ADDENDUM 2

To: All Interested Proposers
From: Araceli Hernandez, Inventory Bid Technician
Date: December 20, 2013
Subject: BID# 13-071, Cabling Services for the New Northwest Annex Building

**Northwest Annex Wireless
EPC-WIFI (COUNTY Wireless ONLY)**

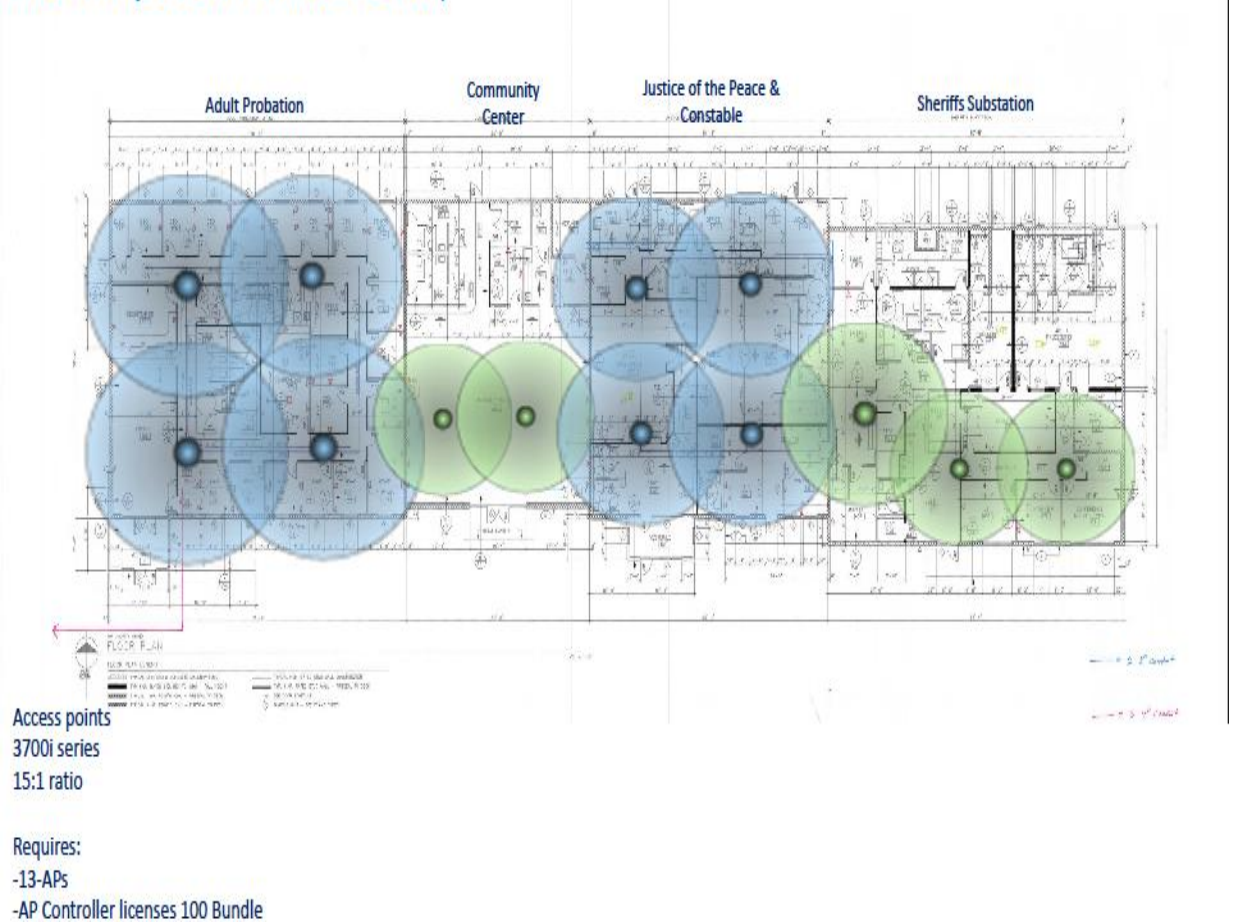
23. I see 3 TYPES of telecommunications outlets. I see 123 Phone/Data (red triangle) outlets, 5 Power Pole (green square) outlets and 3 Floor Box (orange square) outlets on the hand marked drawing. What are the correct counts for the numbers of outlets?

Response: 126 outlets two data and two voice per outlet, 5 power poles with 4 drop per pole two data and voice, 26 drops for wireless access points (two at each location) see below (Northwest Annex Wireless). 550 total drops (color coded)
